5.2 T200589 - Development of the land for six (6) dwellings at 48 James Street, Lang Lang VIC 3984

That a Refusal to Grant Planning Permit T200589 be issued for the Development of the land for six (6) dwellings at 48 James Street, Lang Lang VIC 3984 on the following grounds:

APPLICATION NO.:	T200589
APPLICANT:	Southern Planning Consultants
LAND:	48 James Street, Lang Lang VIC 3984
PROPOSAL:	Development of the land for six (6) dwellings
PLANNING CONTROLS:	Neighbourhood Residential Zone Schedule 1
NOTIFICATION & OBJECTIONS:	<p>Pursuant to Section 55 of the <i>Planning and Environment Act 1989</i>, the application was advertised by the placing of a sign on site and notices in the mail to adjoining property owners.</p> <p>Four (4) objections have been received to date.</p>
KEY PLANNING CONSIDERATIONS:	<p>Clause 55 – Rescode</p> <p>Neighbourhood character</p> <p>Neighbourhood Residential Zone</p> <p>Side and rear setbacks</p>

RESIDENCE 03

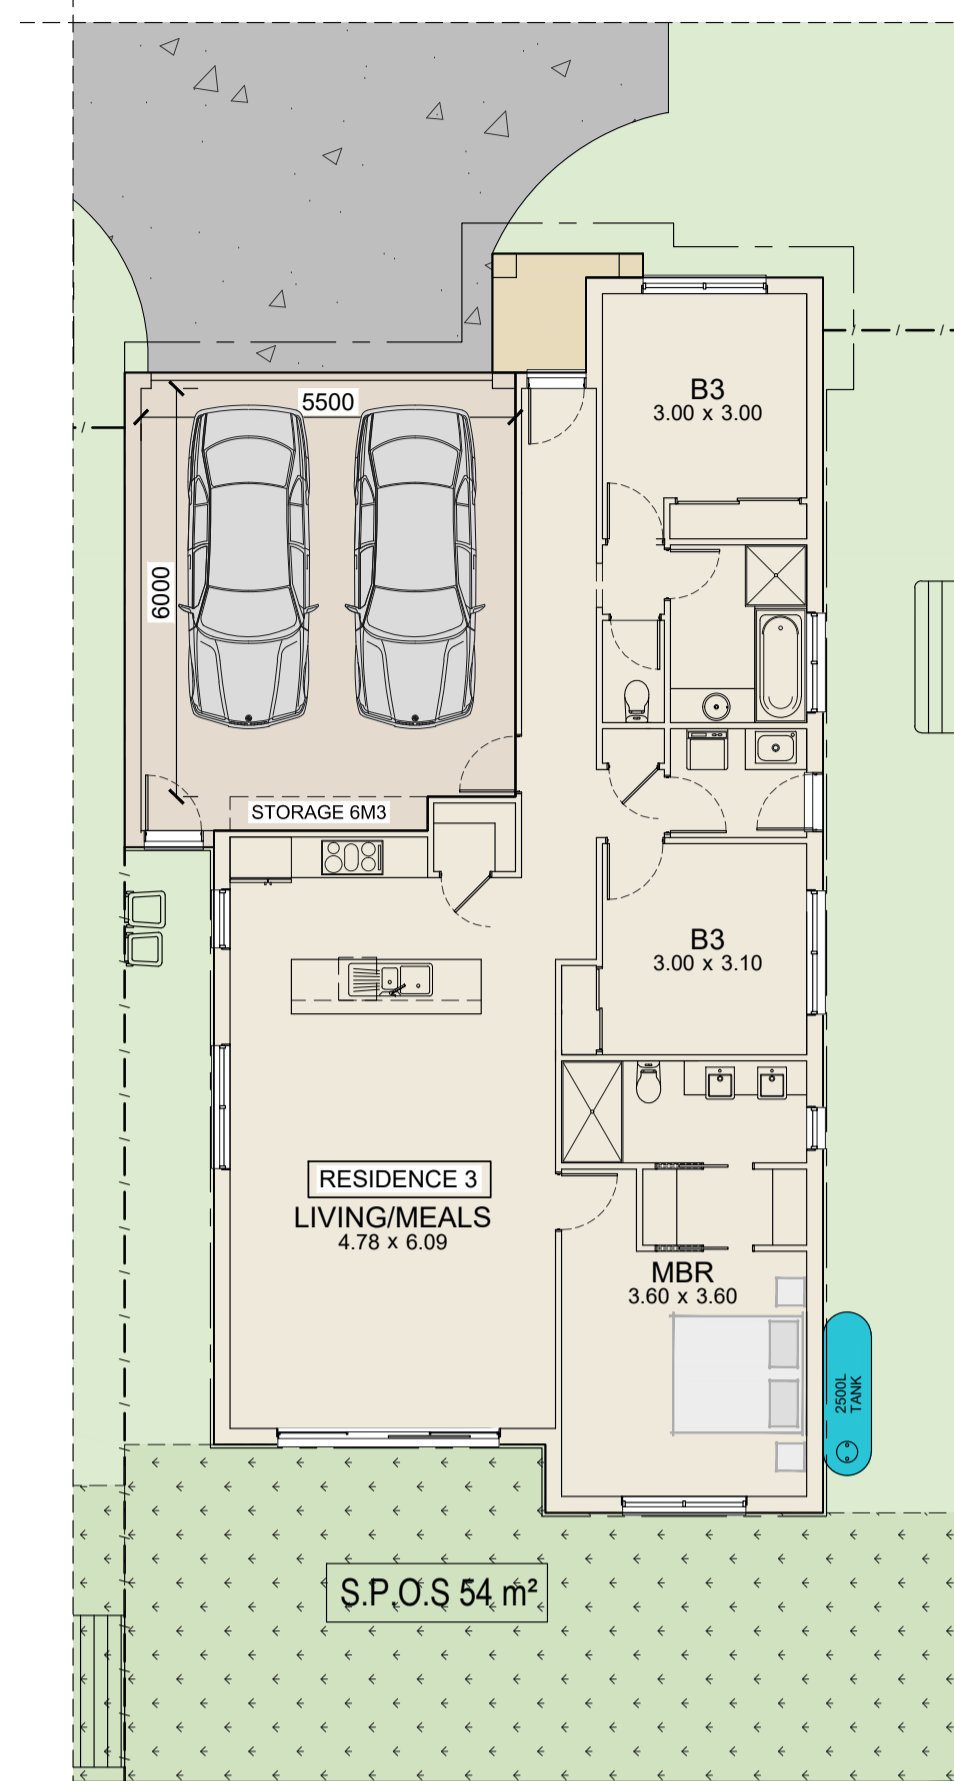
It is noted on the plans that the bedroom labels are duplicated (there are two B3) which will need to be corrected if a permit should issue. The northern-most Bed 3 will accommodate northern sunlight. The second Bed 3 and part of the living/meals area have either east or west-facing windows, whilst the master bedroom and part of the living/meals areas have south-facing windows.

RESIDENCE 06

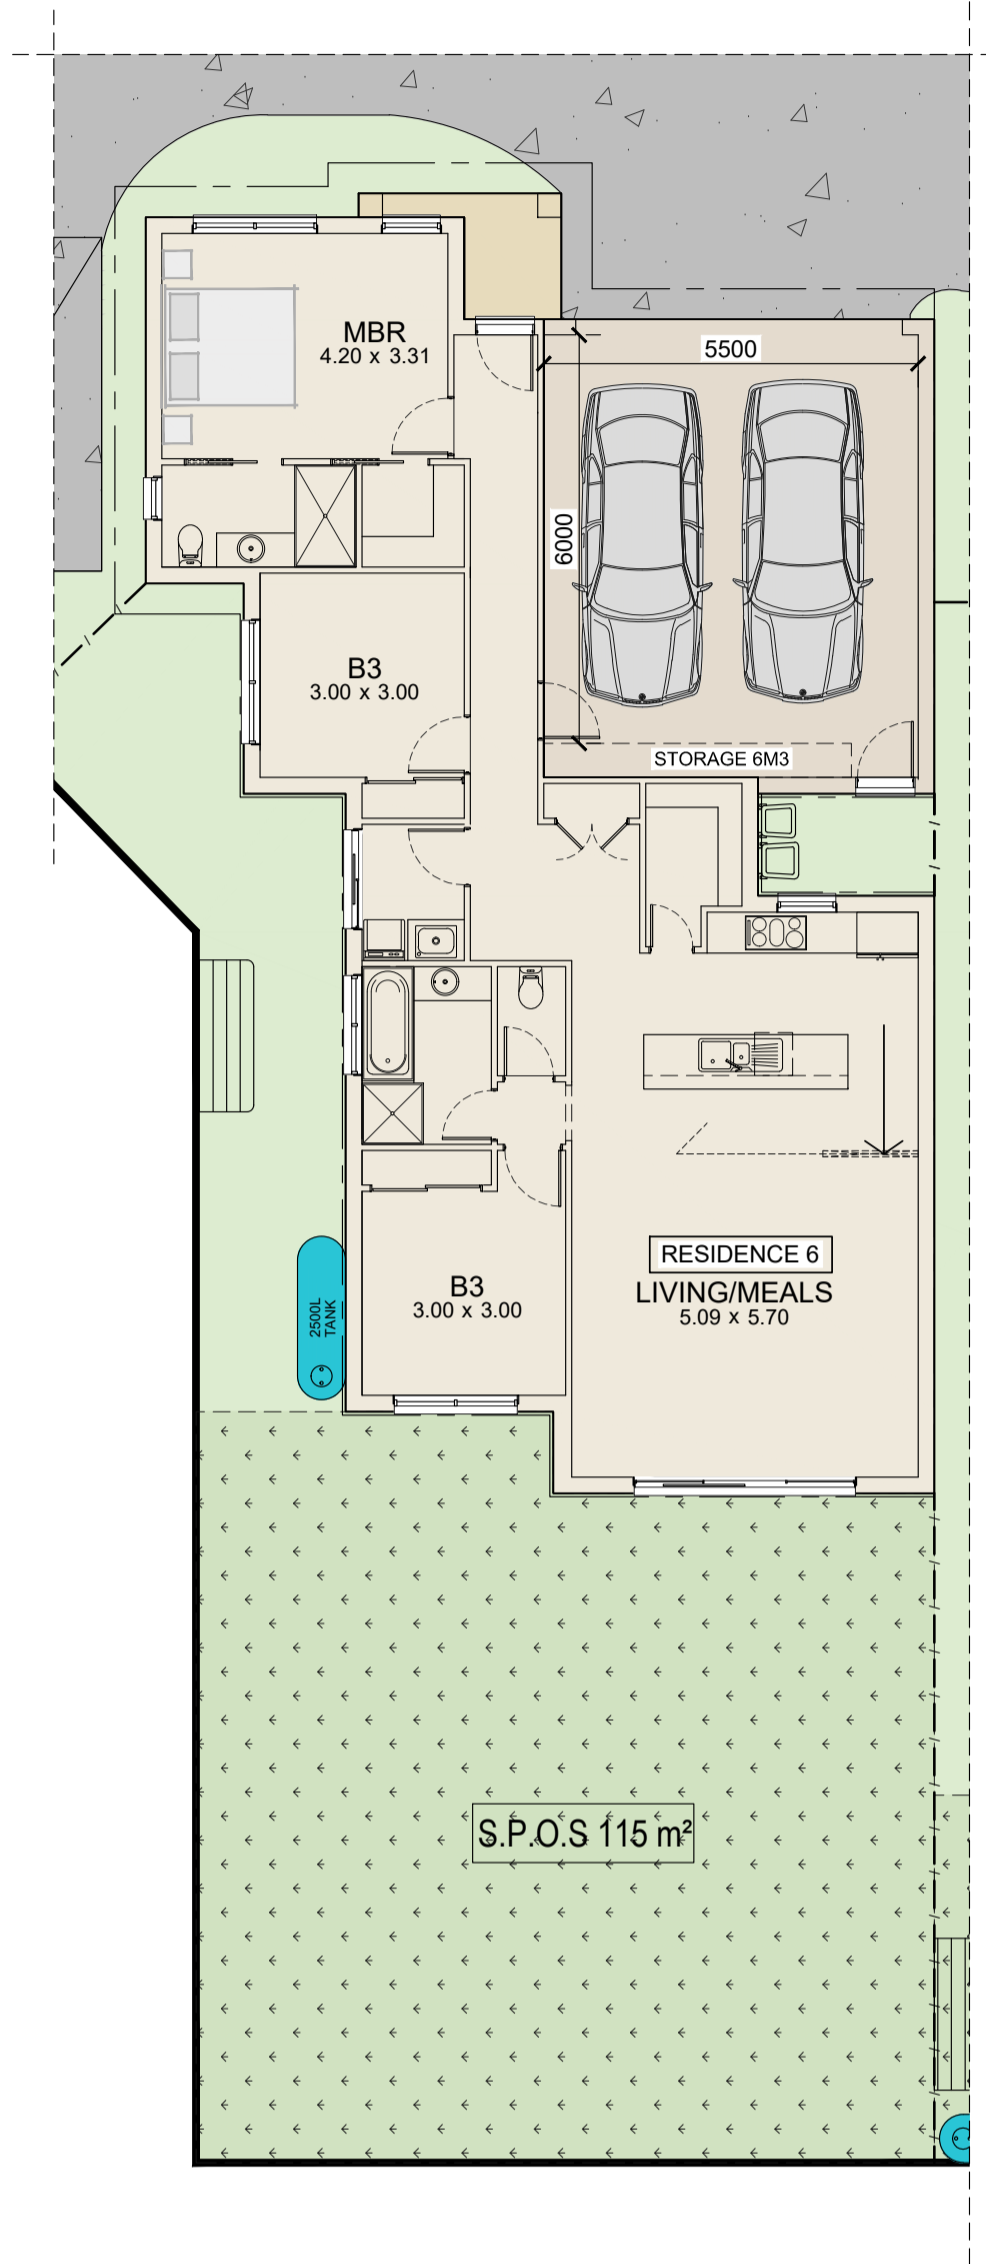
It is noted on the plans that the bedroom labels are duplicated (there are two B3) which will need to be corrected if a permit should issue. The northern-most Bed 3 and master bedroom will accommodate northern sunlight. The second Bed 3 and the living/meals area have south-facing windows.

RESIDENCE 05

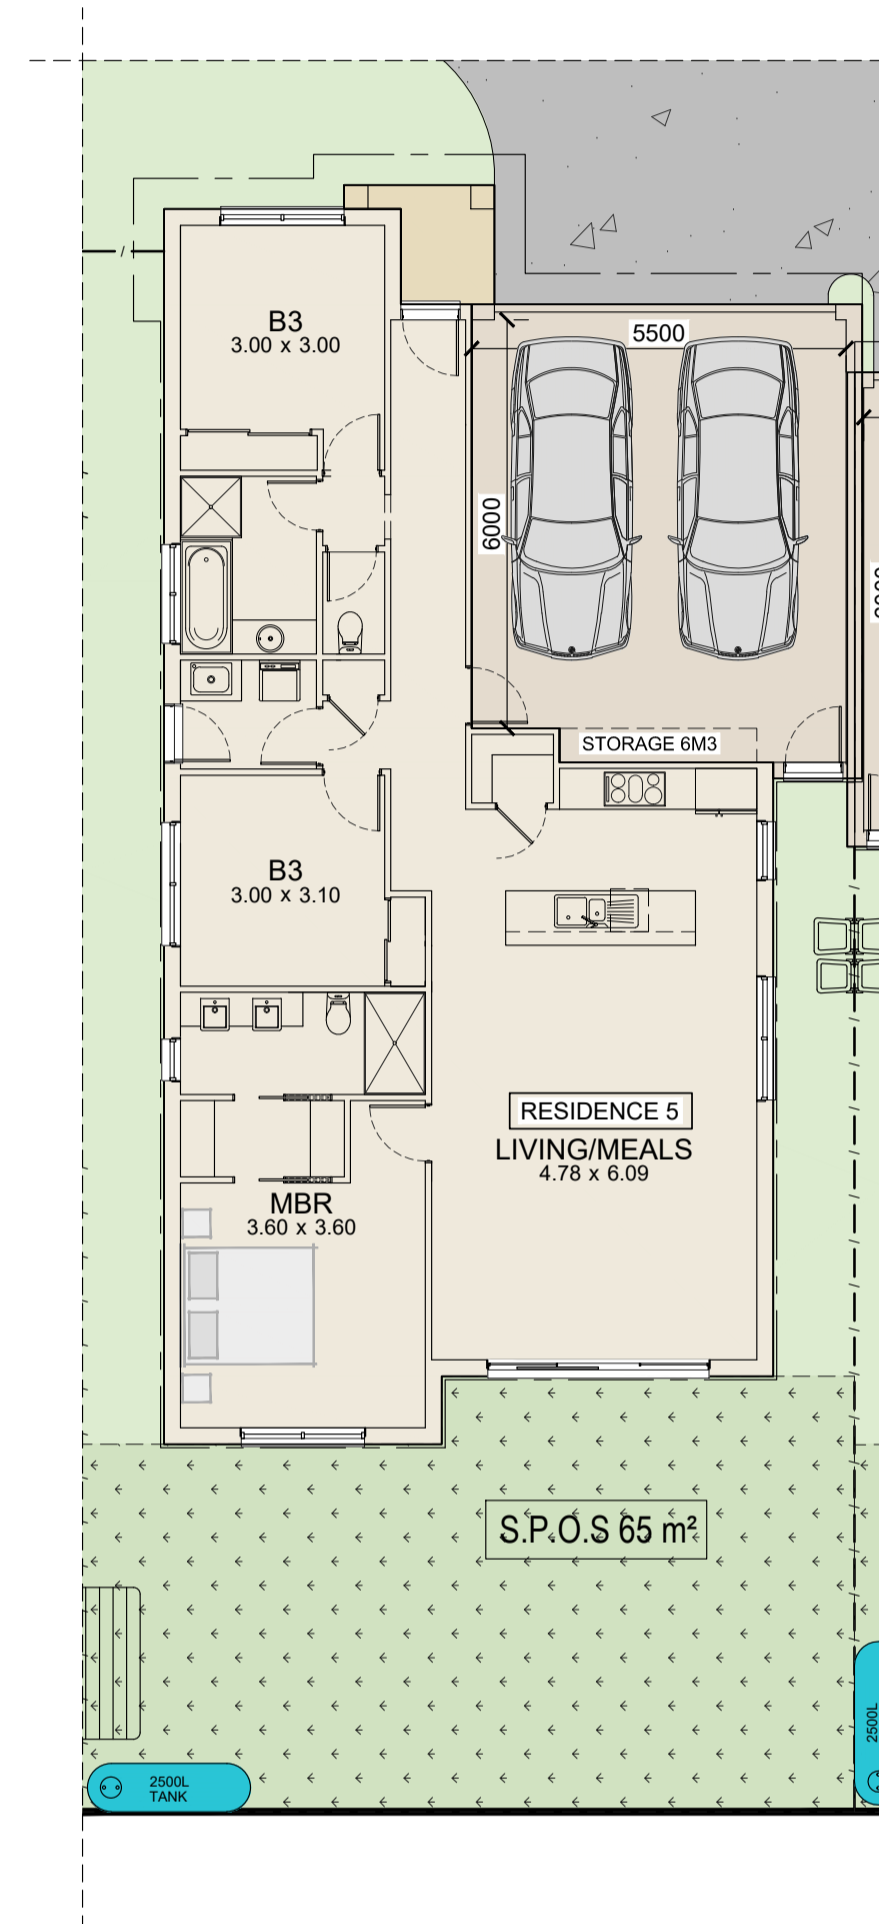
It is noted on the plans that the bedroom labels are duplicated (there are two B3) which will need to be corrected if a permit should issue. The northern-most Bed 3 will accommodate northern sunlight. The second Bed 3 and part of the living/meals area have either east or west-facing windows, whilst the master bedroom and part of the living/meals areas have south-facing windows.

RESIDENCE 04

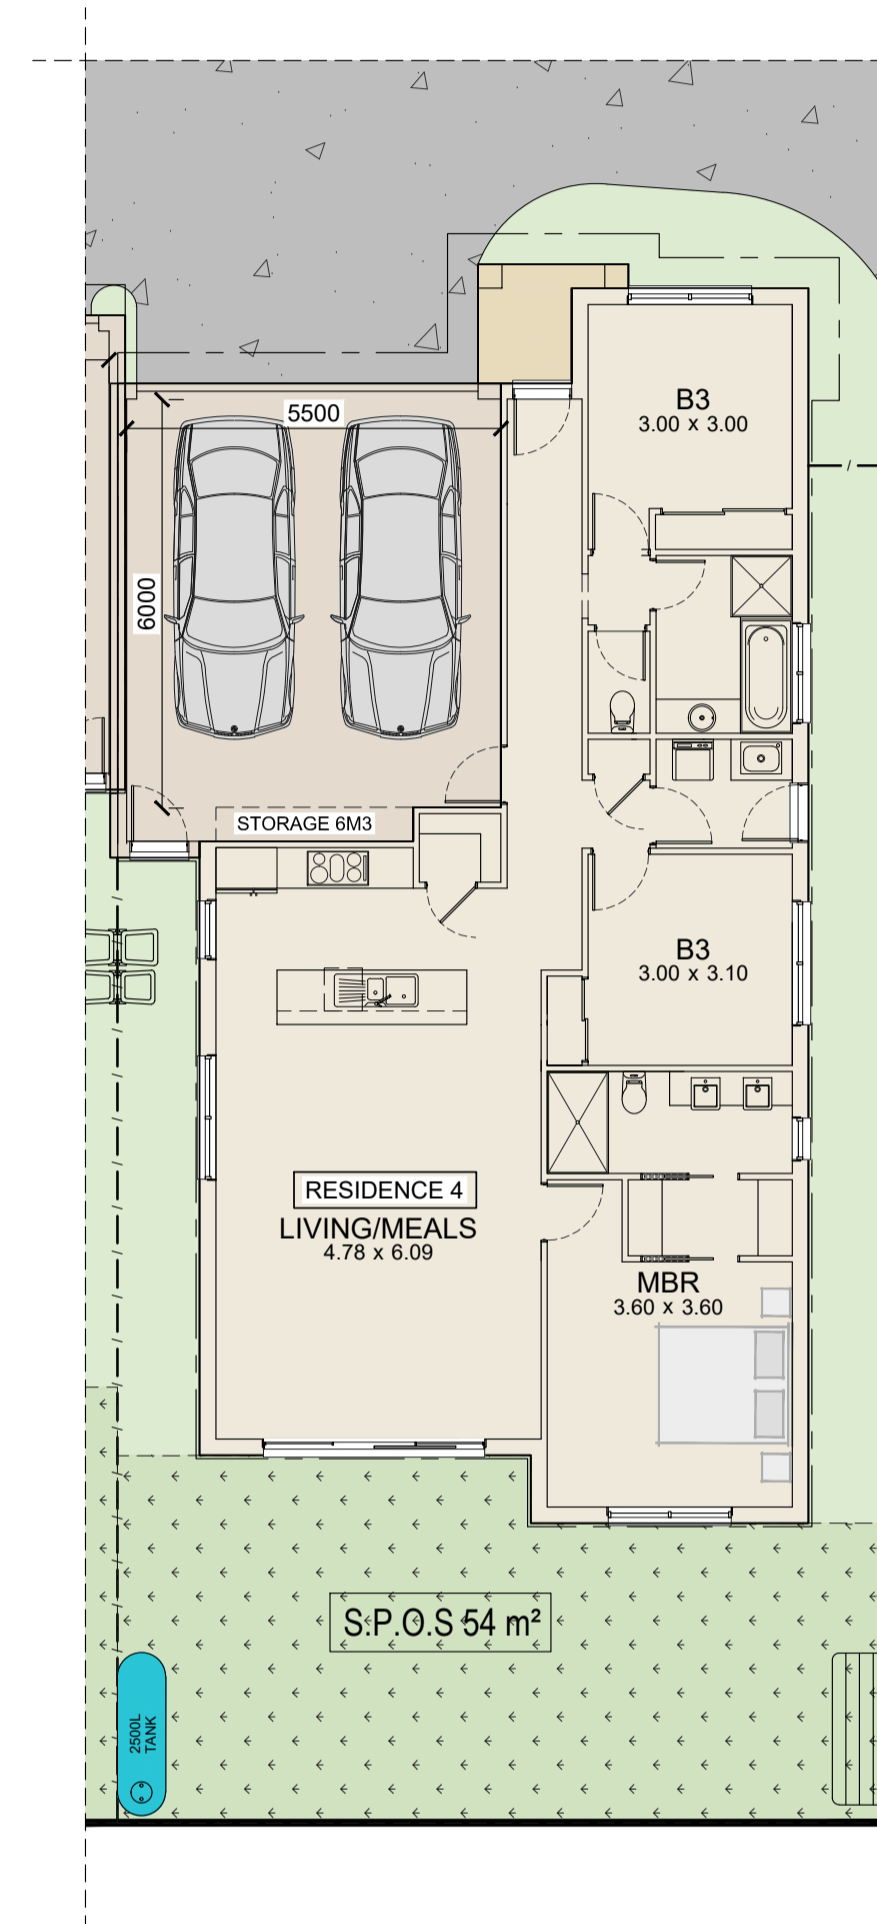
It is noted on the plans that the bedroom labels are duplicated (there are two B3) which will need to be corrected if a permit should issue. The northern-most Bed 3 will accommodate northern sunlight. The second Bed 3 and part of the living/meals area have either east or west-facing windows, whilst the master bedroom and part of the living/meals areas have south-facing windows.
